UNITED STATES PATENT AND TRADEMARK OFFICE

Office Action Summary	Application No.	Applicant(s)
	10/521,804	ROZENDAAL ET AL.
	Examiner	Art Unit
	Jamie L. McGowan	3671

DETAILED ACTION

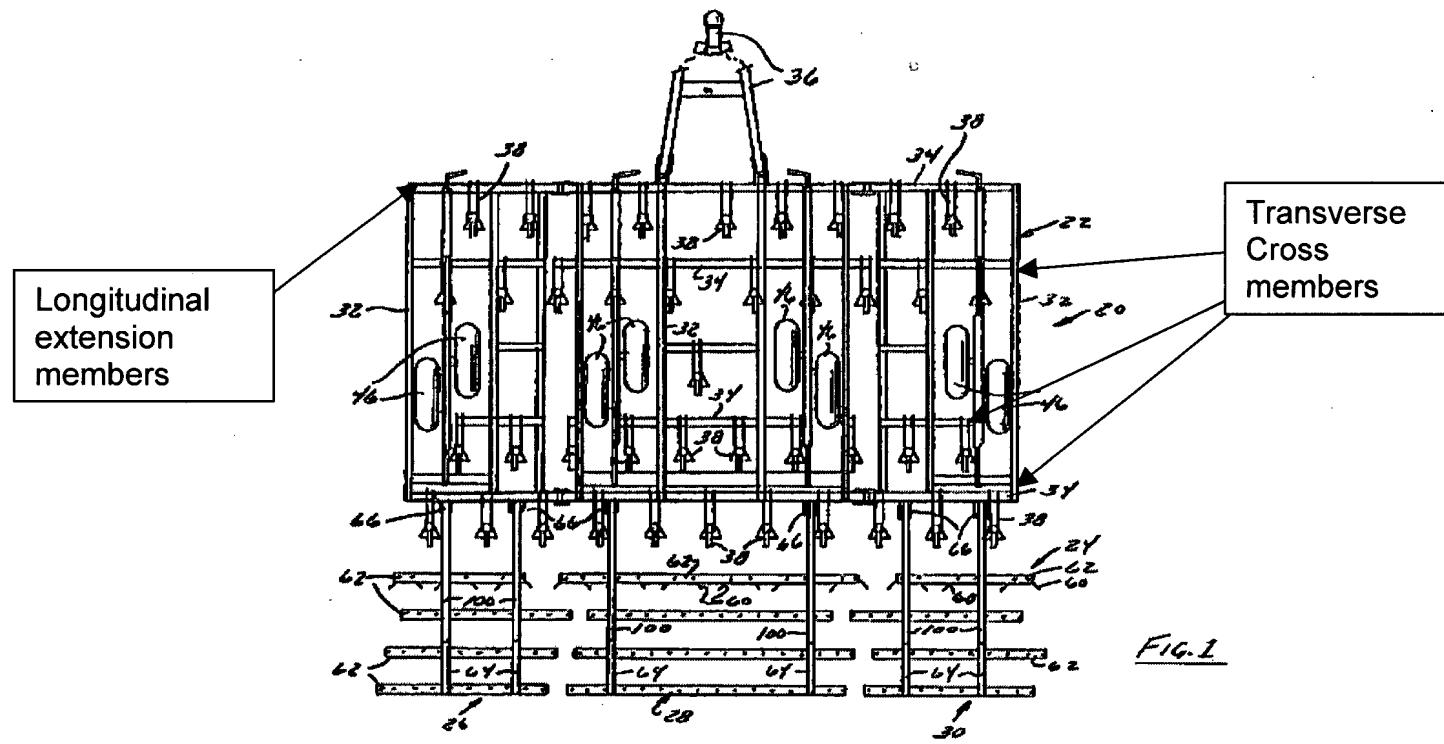
Regarding claim 1, Dietrich, Jr. et al. discloses a tillage implement comprising:

- A frame having three or more longitudinally spaced apart transverse cross members (34)
- A plurality of individual tillage implements (38)
- A mounting means (66) for each individual tillage assembly (38)
- Three or more longitudinally spaced apart rows of laterally spaced apart individual tillage assemblies, each tillage assembly (38) removably mounted on the frame using the mounting means (66), a tillage assembly (38) in a given row being staggered with respect to the coulter wheel assemblies (38) in a longitudinally adjacent row (Figure 1)

Regarding claims 63 and 64, the combination of Dietrich, Sr. et al. and McFarlane discloses that the coulter wheel assemblies are mounted on the transverse cross-members and one or more are mounted to the transverse cross members by longitudinal extension members (See Figure 1 below).

Regarding claim 67, the combination of Dietrich, Sr. et al. and McFarlane discloses that the rows consist of laterally spaced apart coulter wheel assemblies (Figure 1).
